## **Technical Newsletter**

DFD6362 Machine Directive (CE Marking) Specification Instruction Manual Request to Correct Errors Regarding Cover Configuration and Safety Switch Position

Request for verification and correction

Error detail 2: error relating to safety switch position

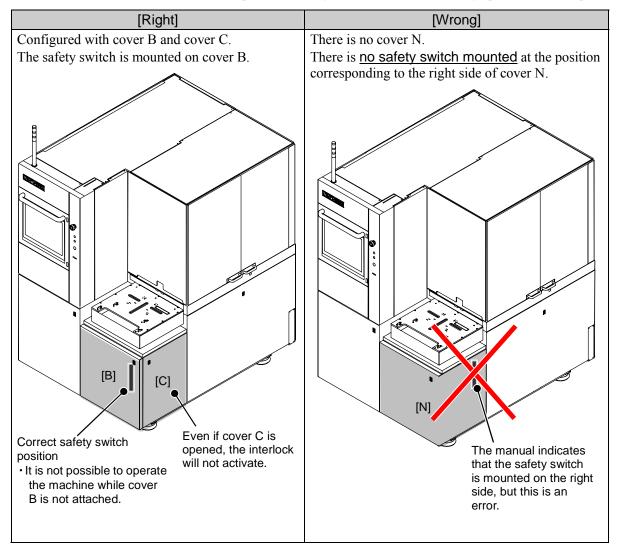
The manual indicates that the safety switch is mounted on the right side of cover N, but this is an error. The safety switch is mounted on cover B (front of machine). There is no safety switch mounted on cover C (right side of machine).

The interlock will not activate even if cover C is opened.

It is not possible to operate the machine while cover B is not attached.

When cover B is opened, the interlock will activate.

### Feature 7: Change in the Configuration of the Outer Cover

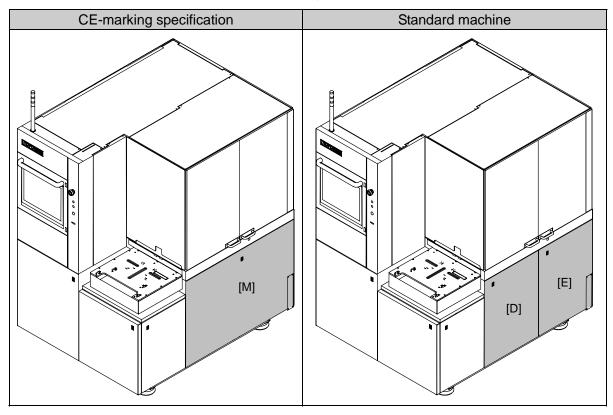
The configuration of the outer covers has been changed as shown below for CE-marking specification.

· Covers [D] and [E] have been integrated together and changed in order to comprise 1 cover (Cover [M]).

For CE-marking specification, please understand the following for the covers indicated in the manuals included as standard accessories.

• Covers [D] and [E] should be understood as meaning cover [M].
